ADDENDUM #1 TO THE TECHNICAL DRAINAGE STUDY FOR MOCCASIN HOMESTEAD WEST

CENTURY
COMMUNITIES

STRIVE
ENGINEERING

March 15, 2022

STORM DRAIN LATERALS
PLAN VIEW
HORIZ. 1"=30'

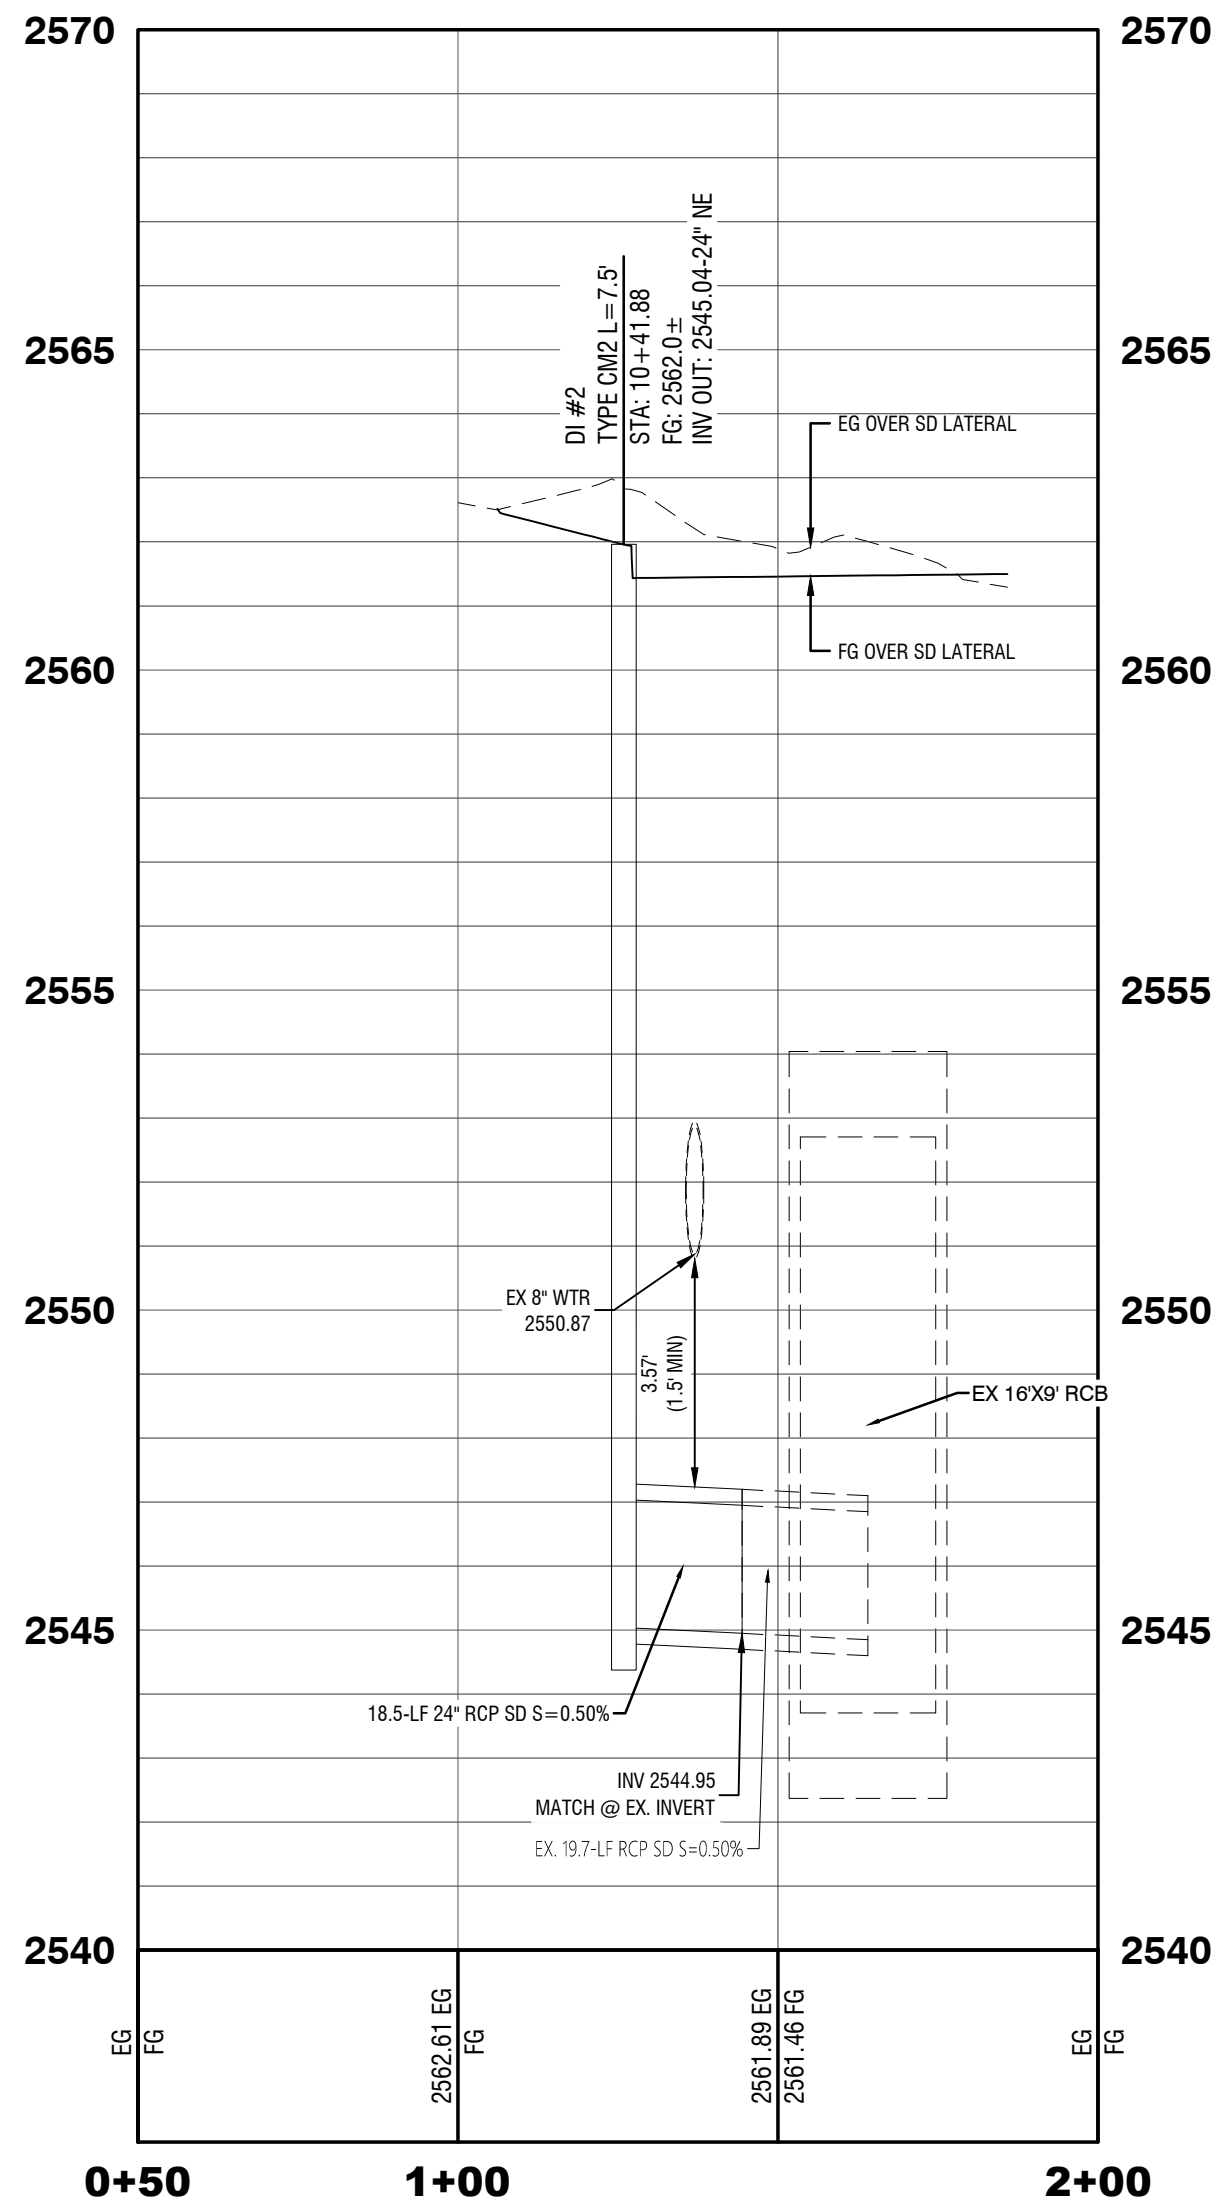
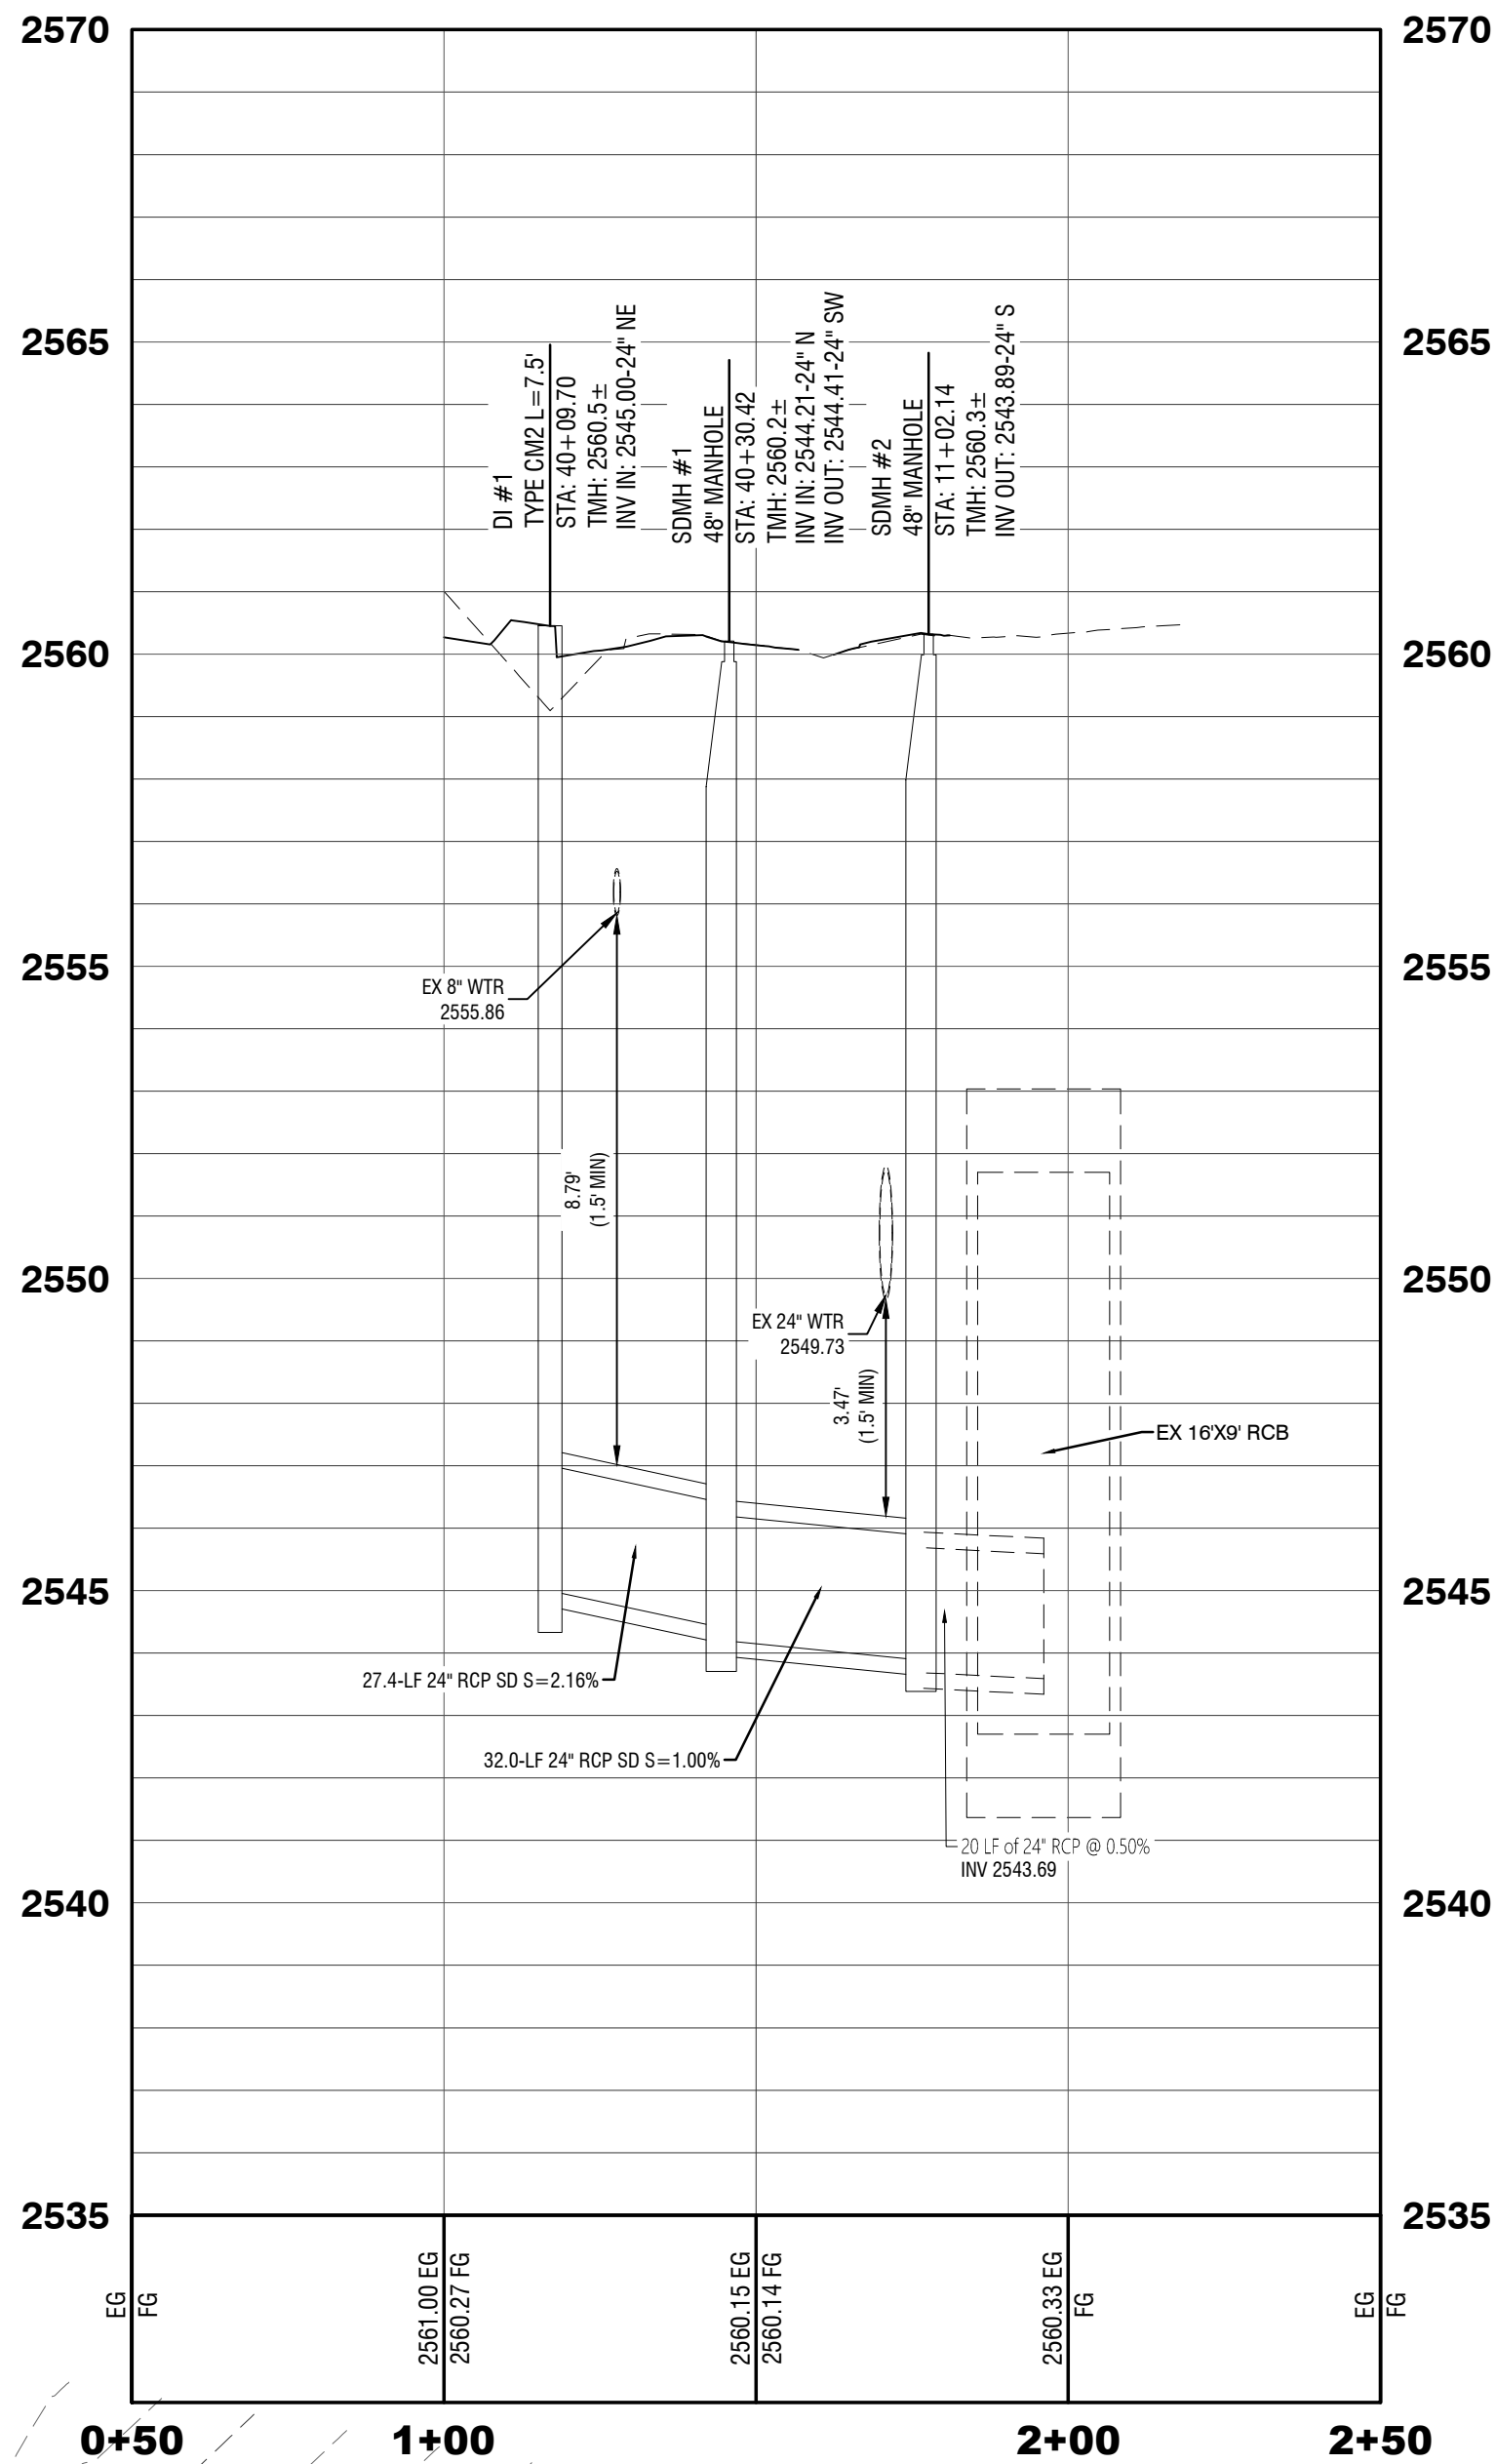
- Response: A dimension call out has been provided on the grading plans to denote the 5' landscape easement for clarity.
- Comment 11:** **GR-01: Provide construction note for the proposed drop inlet in Moccasin Road. Provide plan & profile for the street and inlet.**

Response: Constructions notes for the proposed drop inlet and storm drain system has been added to the grading plans and separate plan and profile sheet have been cut for the storm drain laterals.
